## ADDENDUM NUMBER 3

**1.01 DATE: MARCH 24, 2021**

**1.02 PROJECT: WELCOME CENTER**

**1.03 PROJECT NUMBER: DCM NO. 2020604**

**4.26 SHEET E-7.3 – SECOND FLOOR PLAN – HVAC EQUIPMENT CONNECTIONS:**

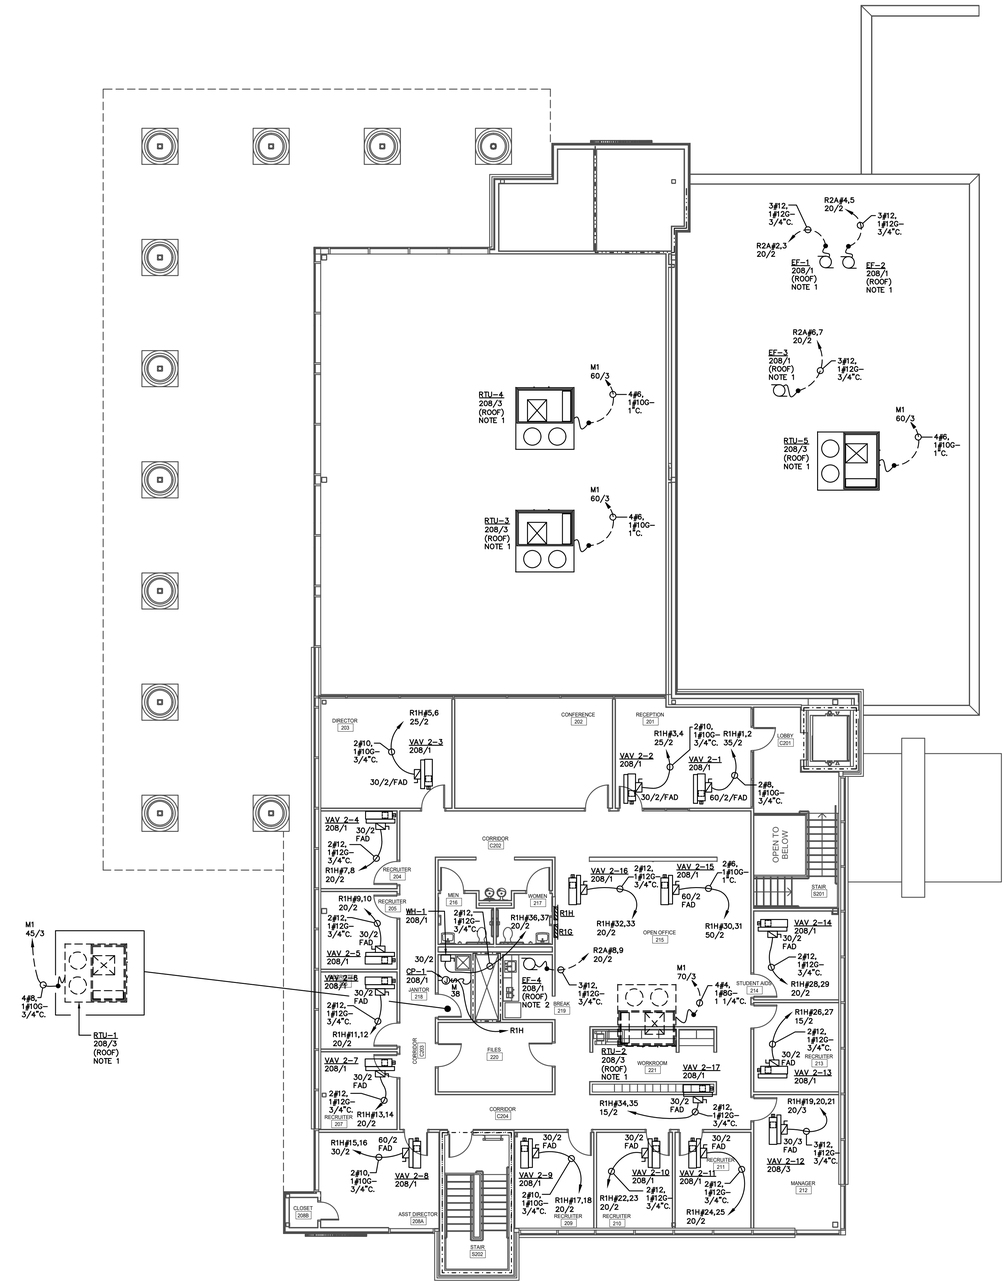
A. Replace this sheet in its entirety. Revisions include the following:
   1. Revised sheet note 1 to read as follows: UNIT FURNISHED WITH INTEGRAL SAFETY SWITCH AND POWERED GFCI CONVENIENCE OUTLET.
